UNITED STATES PATENT AND TRADEMARK OFFICE

APPLICATION NO.	FILING DATE	FIRST NAMED INVENTOR	ATTORNEY DOCKET NO.	CONFIRMATION NO.
10/696,791	10/30/2003	Joseph Schlegelmann	46107-0087	8130
57444	7590	04/28/2006	EXAMINER	
AUTOMOTIVE COMPONENTS HOLDINGS, LLC c/o MACMILLAN SOBANSKI & TODD One Maritime Plaza, Fourth Floor 720 Water Street Toledo, OH 43604-1853			BINDA, GREGORY JOHN	
		ART UNIT	PAPER NUMBER	
		3679		
DATE MAILED: 04/28/2006

Office Action Summary	Application No.	Applicant(s)
	10/696,791	SCHLEGELMANN ET AL.
	Examiner	Art Unit
	Greg Binda	3679

Annotated Drawing Sheet

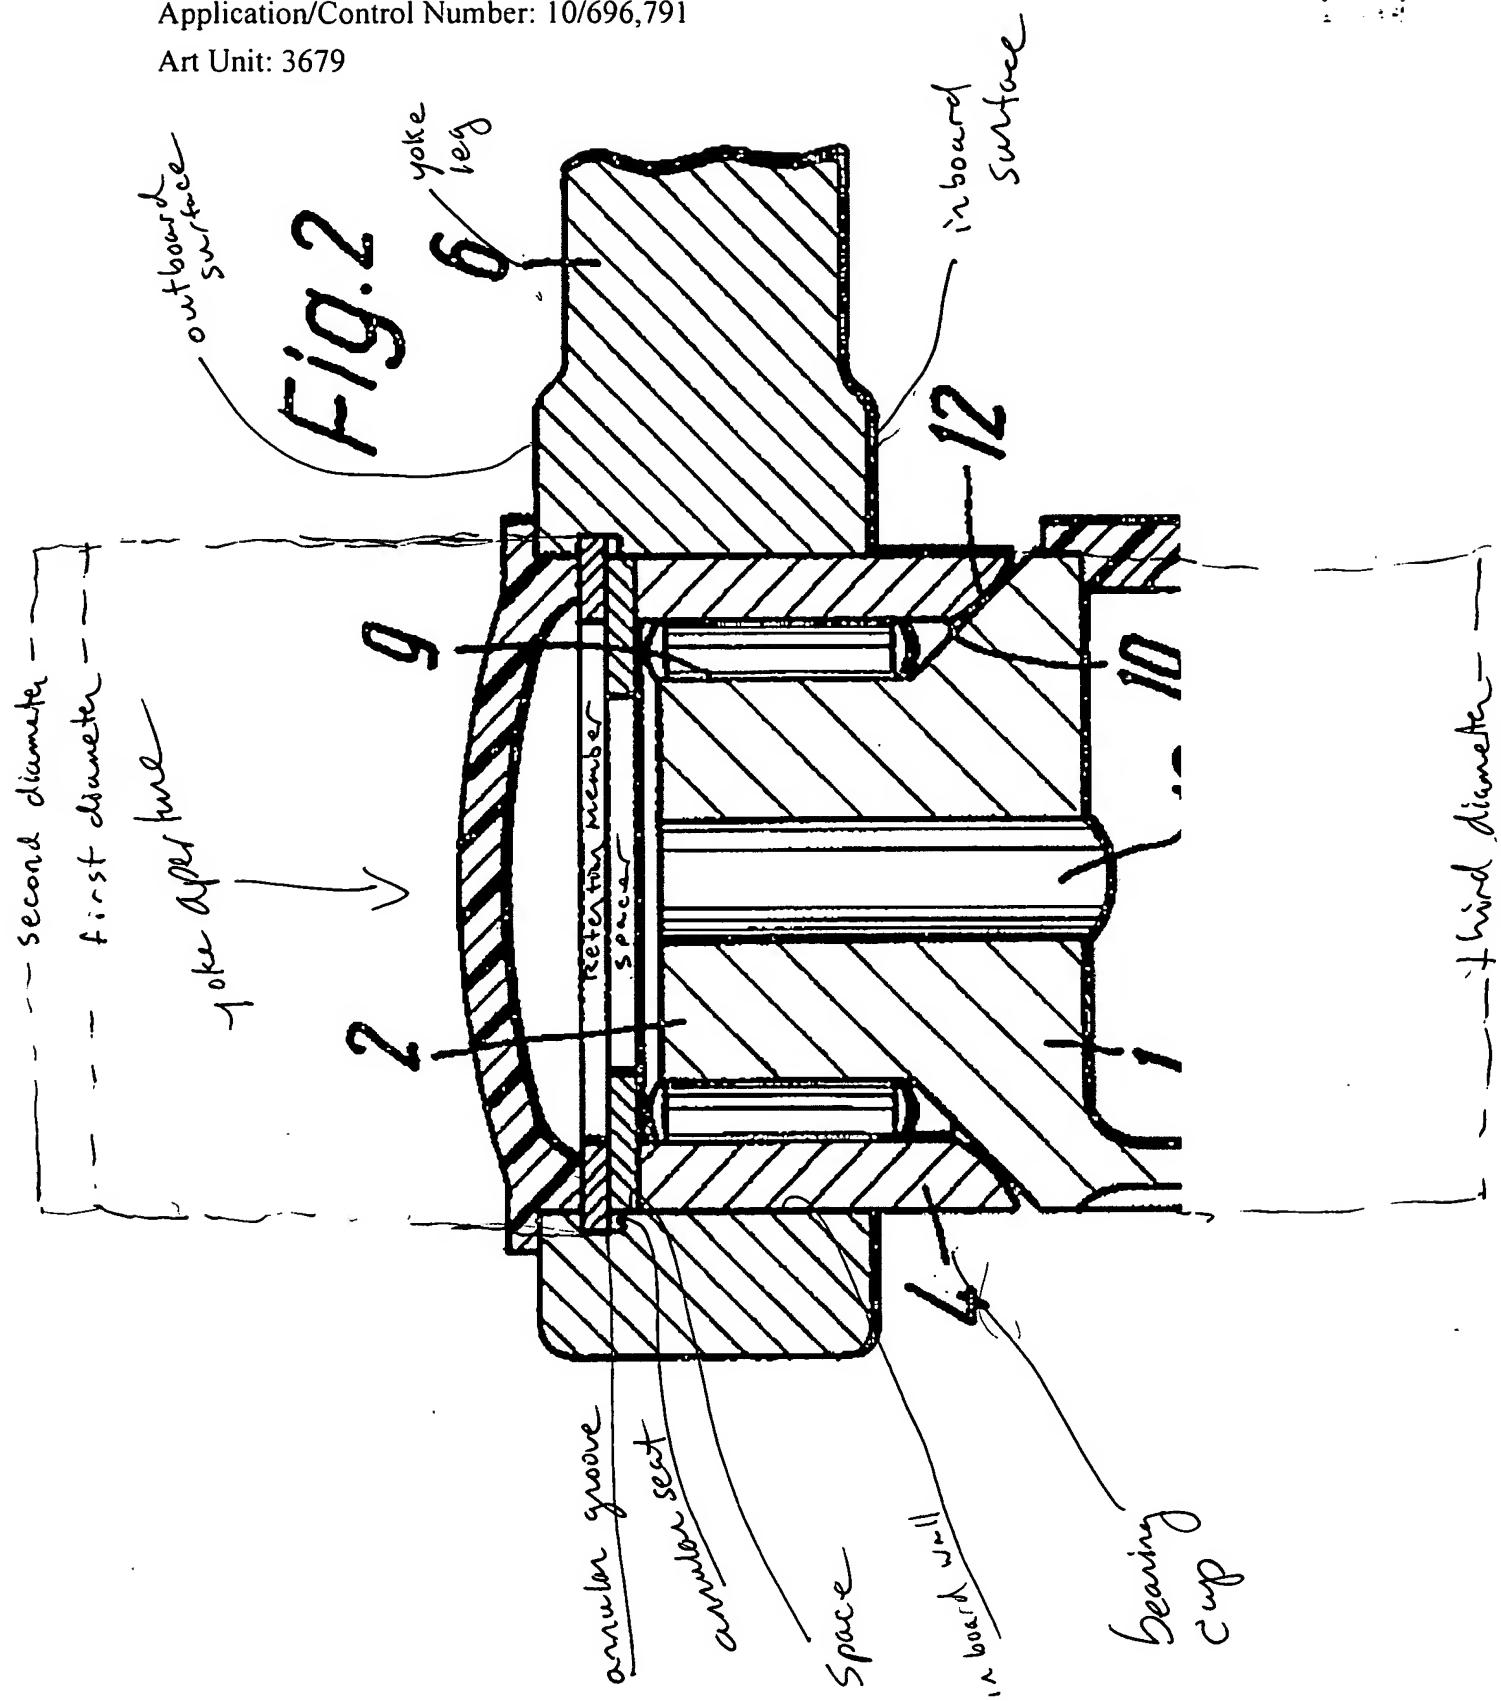
6. Claims 1 & 5-7 are rejected under 35 U.S.C. 102(b) as being anticipated by Girquis, US 3,881,324 (see particularly the attached annotated Fig. 2). Girquis shows a universal joint comprising: a yoke leg 6 with an aperture; a bearing cup 4; a retention member; and a spacer. Fig. 2 shows the aperture of the yoke leg comprises: an annular groove in which resides the retention member; a first diameter (the diameter of the portion of the annular groove occupied by the retention member); a second diameter (the diameter of the portion of the annular groove not occupied by the retention member) inboard of the first diameter; an inboard radial wall having a third diameter that is smaller than the second diameter; an annular seat (the inboard lateral surface of the annular groove); and a space below the annular seat in which resides the spacer.
